**RZN18-0006**  
**The View PRD**

## **RZN18-0006 The View PRD Staff Appendix**

**An Advisory Memo for the Town of Blacksburg**  
on Best Practices for Multi-Family Development  
and a Critique of Three Proposed Projects

RE: Planned Residential District for The View  
Graystone Companies, LLC  
Toms Creek Road, Adjacent to US 460 Bypass  
Town of Blacksburg, Virginia

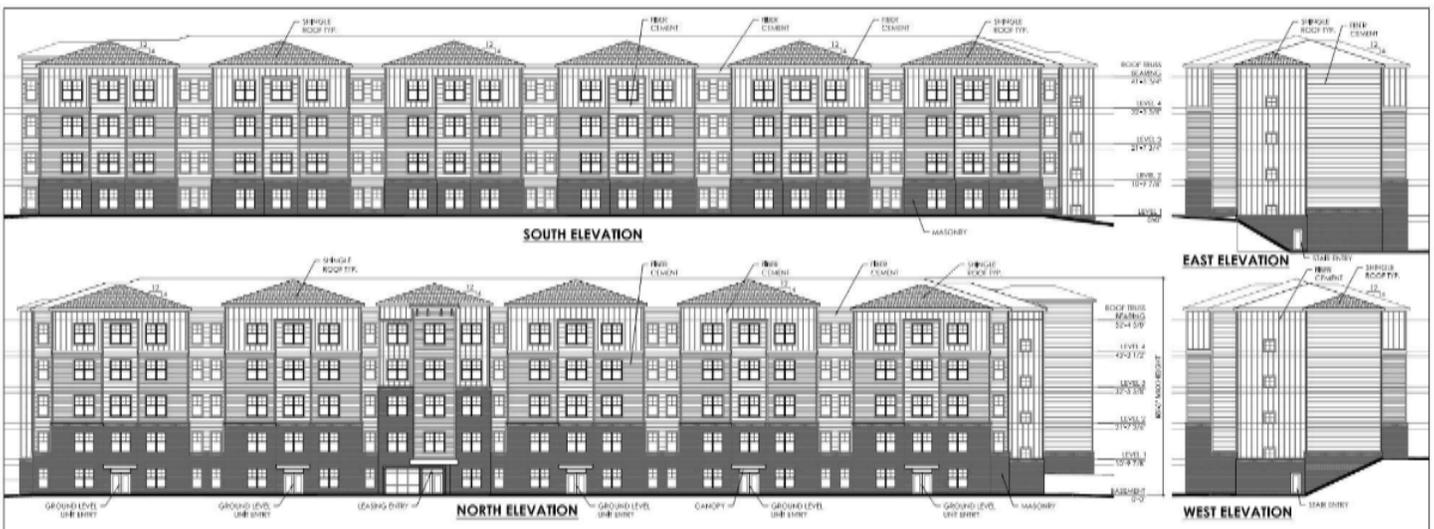
The designer did an effective job breaking down the long façade into smaller pieces by dividing the building into six portions, although the design is basic and a bit monotonous. The façade can be broken up further by adding vertical reliefs and reveals on the wall that accentuate its height and detract from its width. Taller windows may also help make the building seem lighter.

The material changes add visual interest and help divide the tall building into three distinct sections, making it feel more human scaled. However, the Town should insist that high quality materials such as stone and fiber cement siding are used. Cheaper alternatives such as vinyl siding do not age well over time and are not appropriate for multi-family developments such as this.

The design for the building can be improved by making the lobby/common area more prominent. At a functional level, the main entrance needs to be easily identifiable to detract guests and newcomers from approaching the ground level unit entries. Beyond that, it's also important to consider that this common area is the first space potential renters will see, and it can also serve as a social space for the apartment where students can relax, study, hang out, and collaborate. Thus, it's important that the space is highly visible and visually appealing.

Unfortunately, in this case the entrance is not centered on the building and has a commercial-style window on only one side, making it feel strangely lopsided. The differentiating fiber material directly above the doorway and the larger canopy helps accentuate it to a degree, but more should be done to enhance this key area of the building. At a minimum, matching commercial-style windows should be on both sides of the door and landscaping should be used to help make this area a focal point. It may also be helpful to change the style of the canopy to further differentiate it from the overhangs above the ground level entry units.

Another consideration is the window sizes and placements. Currently, the design has three main windows and two smaller windows for the four-bedroom units. Assuming that the living room will have a main window, only two of the bedrooms will have a main window and the other two will have smaller windows. Because student bedrooms are typically smaller than the average bedroom, consider adjusting the floor plan and window placements to allow all bedrooms to have windows the size of the main windows. This ensures that every user of the unit will have a bedroom that will appear more spacious and will allow for more natural light. For the southern façade, it may be appropriate to add overhangs of appropriate depth to cast off direct sunlight over the summer.

## TRANSPORTATION SYSTEM & CONNECTIVITY

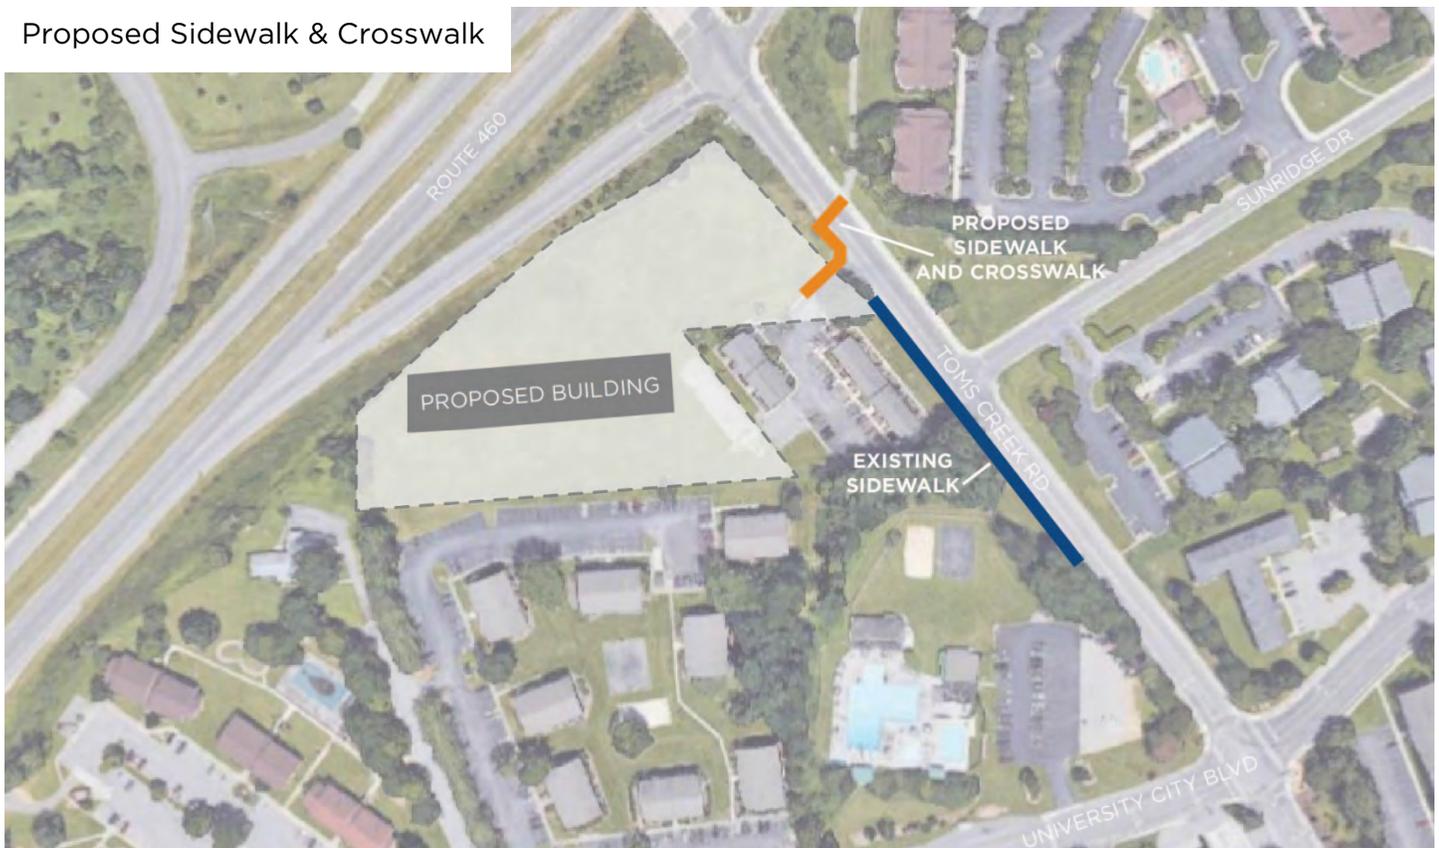
Although some basic pedestrian accommodations have been made, the layout for The View is not particularly pedestrian friendly. As currently designed, a pedestrian must walk over 400 feet from the building through a parking lot to Toms Creek Road before beginning their journey. It will be important to ensure that there is an ADA accessible pathway from the Toms Creek sidewalk to the building. The plan does not currently show the required connection between the internal sidewalk network and the existing public sidewalk on Toms Creek Road, a basic issue which must be addressed along with the lack of a sidewalk ramp near the entrance to this site. Typically, a development such as this would be required to construct a sidewalk along the entire length of the property on Toms Creek Road. In this particular case, that sidewalk would not lead to any kind of pedestrian space on the existing overpass, so it may not be useful. However, the Town may want to consider requiring a short extension of the sidewalk in that direction in order to provide a better crossing to Givens Trail, a suggestion which discussed further in the following paragraph.

There are minimal provisions made for cyclists other than a few bike racks. The main two racks in the front of the building are placed directly in front of the ground level unit entry doors, suggesting that little thought has been put into their inclusion. The applicant doesn't provide any specific information about the racks, but an inverted u-type rack should be utilized as it provides support for the frame of the bike and offers better security. In order to truly encourage cycling, these racks should be covered,

well-lit, and conveniently placed on the site. In regards to surrounding bicycle infrastructure, a narrow bicycle lane is currently present on Toms Creek Road and the Town’s Bicycle Master Plan indicates that the road is a designated bicycle route. The Town should consider requiring the applicant to improve the roadway along their street frontage to provide the recommended width of 5 feet as part of the development process.

**FIGURE 3-4 PASSING/LEFT TURN LANE**

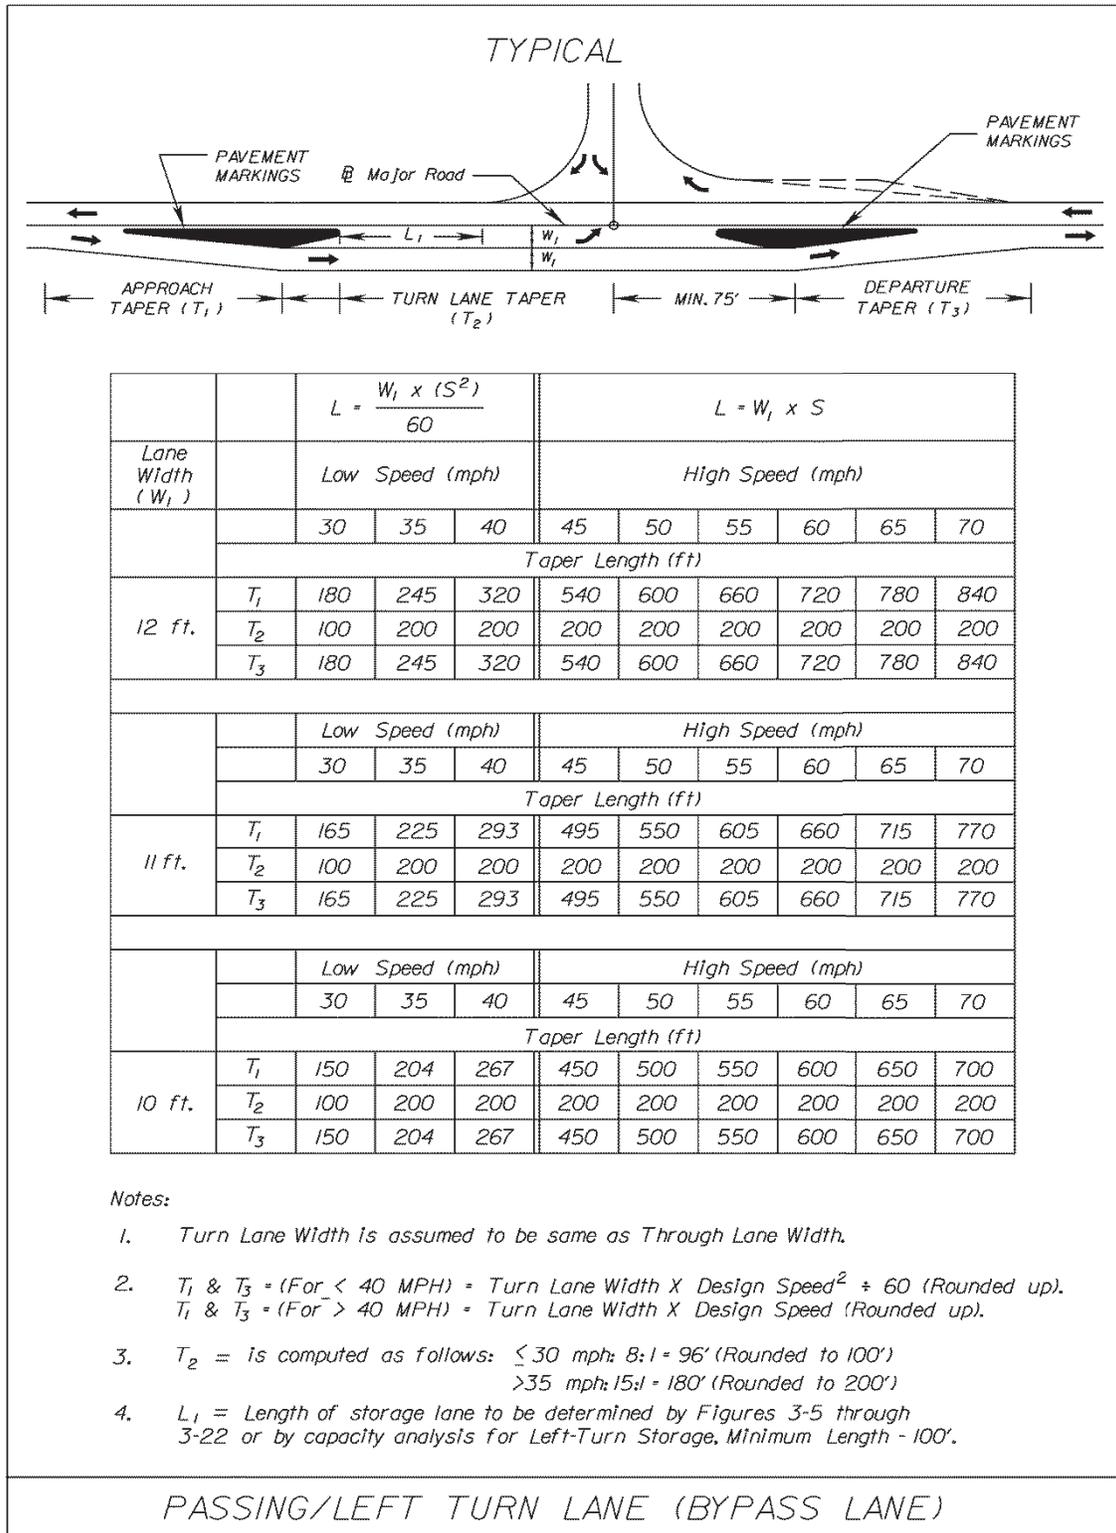
While an existing access point does exist, the proposed traffic addition is considered a change in use and should be evaluated with Access Management Regulations. The access's location, relative to an interchange and limited access, is of some concern; however, equally concerning is the width and configuration of the entrance given the anticipated increased traffic at this location. The TIA submittal shows no improvements to the entrance; however, there is a proffer to add a Two-Way Left Turn Lane (TWLTL), which would generally require reconstruction of the entrance. At a minimum, a document should be provided to show the roadway and entrance improvements to incorporate the TWLTL to see what effects it has on the limited access area/interchange, effects to existing utilities, and if adequate right of way exist without additional dedication of right of way. Generally, the minimum required pavement widening would extend beyond both the entrance to the property and the intersection of Toms Creek Road and Sunridge Drive. With a dedicated left turn lane at the intersection of Toms Creek Road and Patrick Henry Drive, it may be more appropriate to extend the pavement widening to the existing dedicated left turn lane at Patrick Henry. Using the minimum VDOT widening/transition details, there would be approximately 100 LF between the limit of this widening and the existing left turn transition. While there is a proffered condition to include a TWLTL between Sunridge Drive and the site entrance, a "stacked" left turn lane in each direction may be more appropriate. An example of a "stacked" left and the generic detail for turn lane tapers are attached for reference.
